Proposed Changes to California Building Code, Access Standards

Comments by PW-Engineering ADA Curb Ramp Committee

December 10, 2012

1. Landings for parallel curb ramps

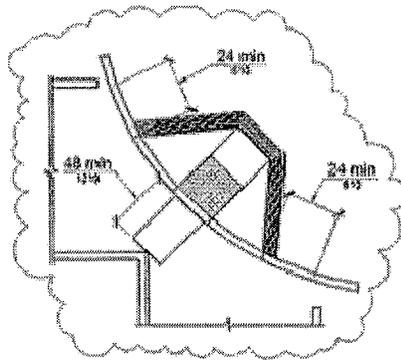
Comment: The turning space level landing at the bottom of the curb ramp is an issue when the existing street have more than 2% slope.
